STAFF REPORT

SUBJECT: H-2020-0078
1625 E. Bentley Drive

I. PROJECT DESCRIPTION

Annexation & zoning of 1.55 acres of land with Community Business District (C-C) zoning district to allow a 4,800 sf +/- office flex building, by Clint Hansen of Land Solutions. The applicant may eventually build a second commercial building.

C. Proposed Elevations (date: 6/26/2020)

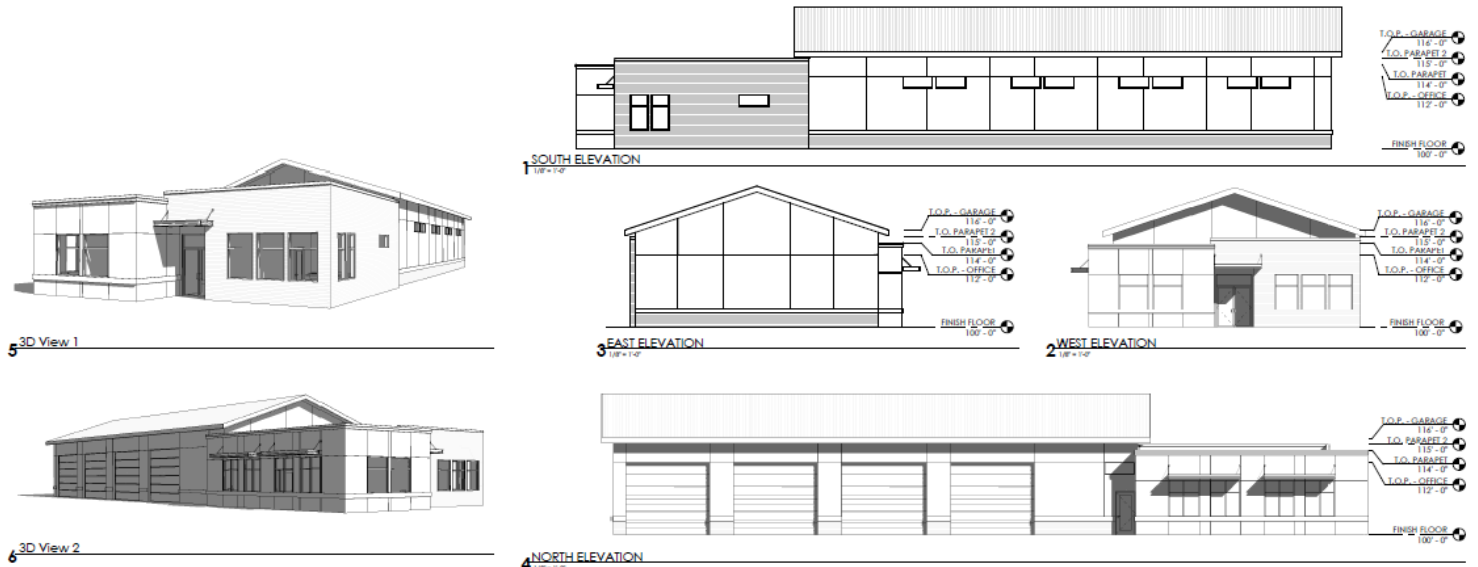
The conceptual elevations show a one-story office building comprised of metal and fiber cement siding, with a sloping roof. As is required by UDC 11-4-3-18 for flex space, the roll-up doors are faced to the north, away from public streets. At time of CZC and DES submittal, complete architectural elevations with materials called out will be required and the architecture will be reviewed against the Architectural Standards Manual (ASM). It does appear that the conceptual elevations might not meet the standards of the ASM in regard to buildings with rooflines 50-feet in length incorporating roofline and parapet variations. Also, the Applicant should be aware that untextured concrete panels and prefabricated steel panels are prohibited as field materials for building façades, except when used with a minimum of two other qualifying field materials and meeting all other standard fenestration and material requirements. The applicant site and building design is required to comply with the design standards in the UDC and the ASM.

- b. The Commission asked whether the elevations submitted with the staff report would also change. The applicant responded that they probably would. Staff added the elevations submitted probably would not meet the requirements of the Architectural Standards Manual (ASM) but staff would work with the applicant on this during the Certificate of Zoning Compliance (CZC).
